INSTRUCTIONS FOR INSTALLING THE 195528 BLINDING MOD-
IFICATION KIT TO THE 177010 OR 178601 ELECTRONIC SELECTOR-
MAGNET DRIVER

FIGURE 1

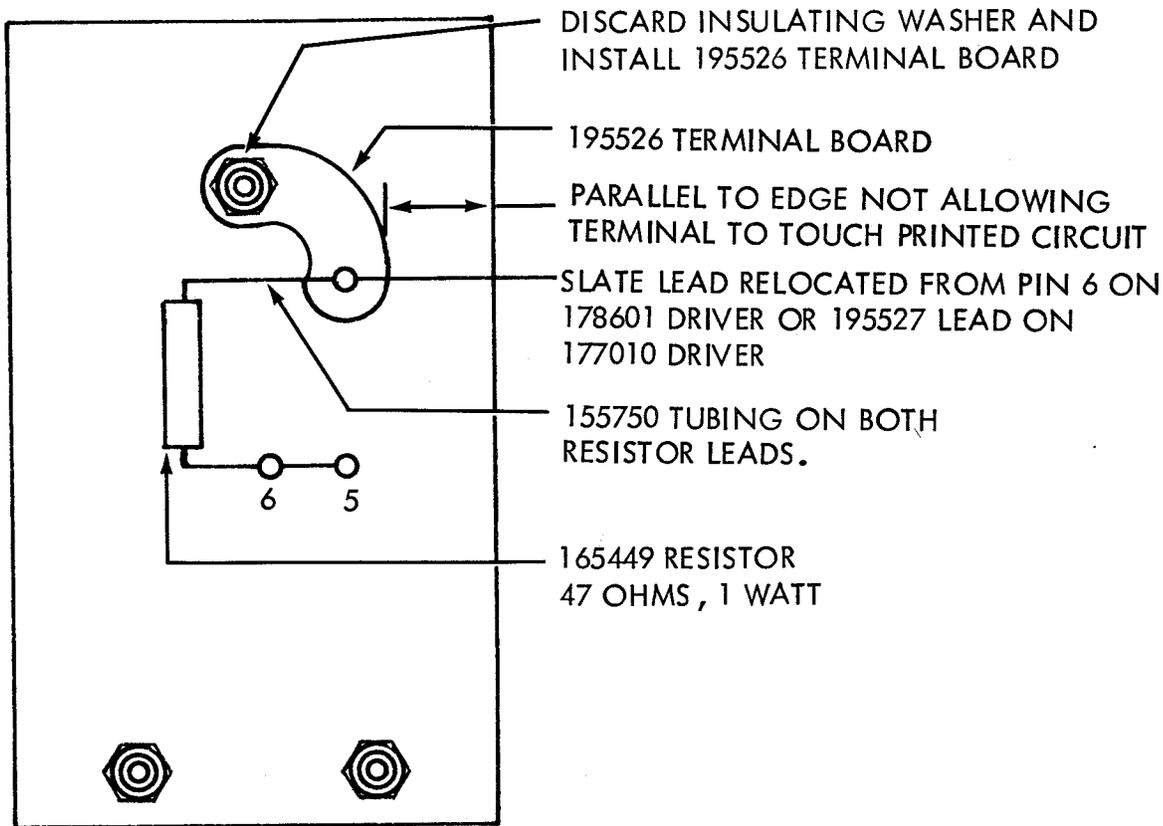
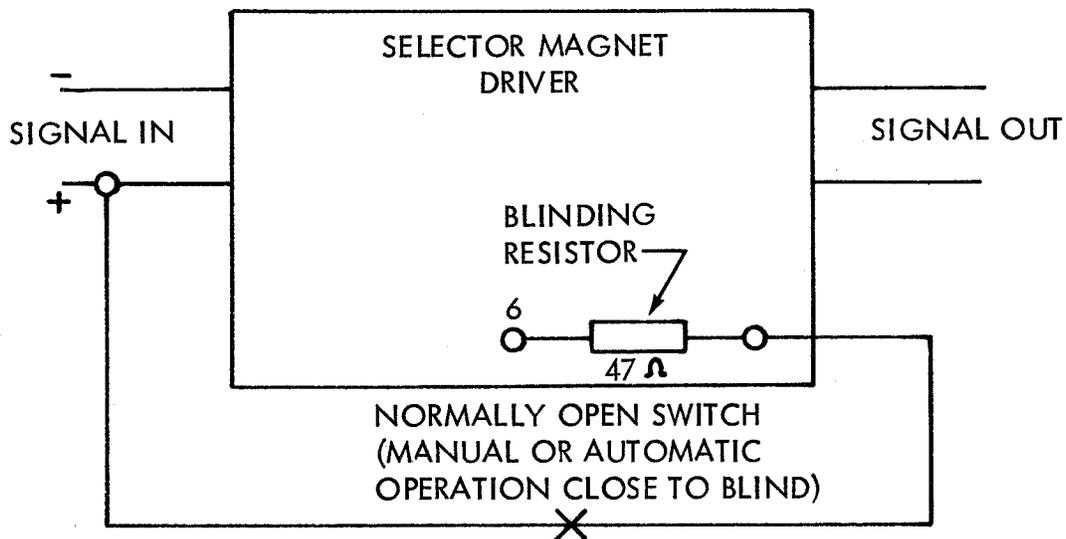
b. Install the 195528 modification kit as shown in Figure 1. The 195527 wire assembly is not used with the 178601 driver.

d. Blinding can be manual or automatic and is optional with the customer. See Figure 1 for typical wiring.
